DOCUMENT NUMBER: <b>FM-000-0004-48</b>	TITLE: <b>Form - Product Change Notice</b>	
REVISION: H DCO# DC0005391	DOCUMENT CLASSIFICATION: 04-Forms, Templates or Other

**PCN Number:** PCN48801301-0002    **Revision:** A    **Creation Date:** 04 Oct 2023

Part Number	Item Description
<b>48-8013-01</b>	ASSY,CARTRIDGE,INTELLIXCAP,96,AZENTA,INT

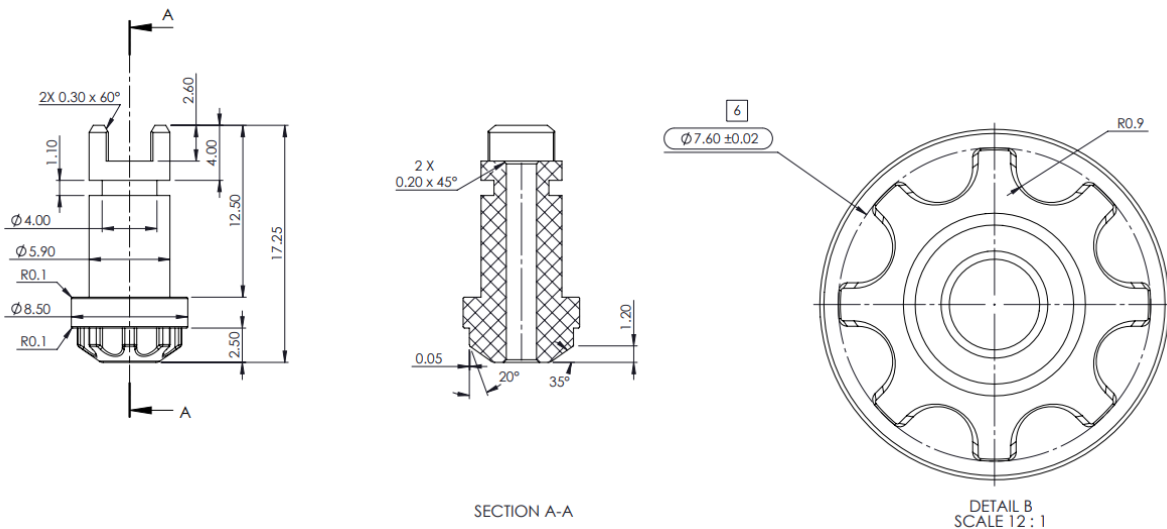
The new cap driver has been designed to improve engagement with the caps. Please see below, for information only, the new design of the affected part, with the new dimensions and geometry:
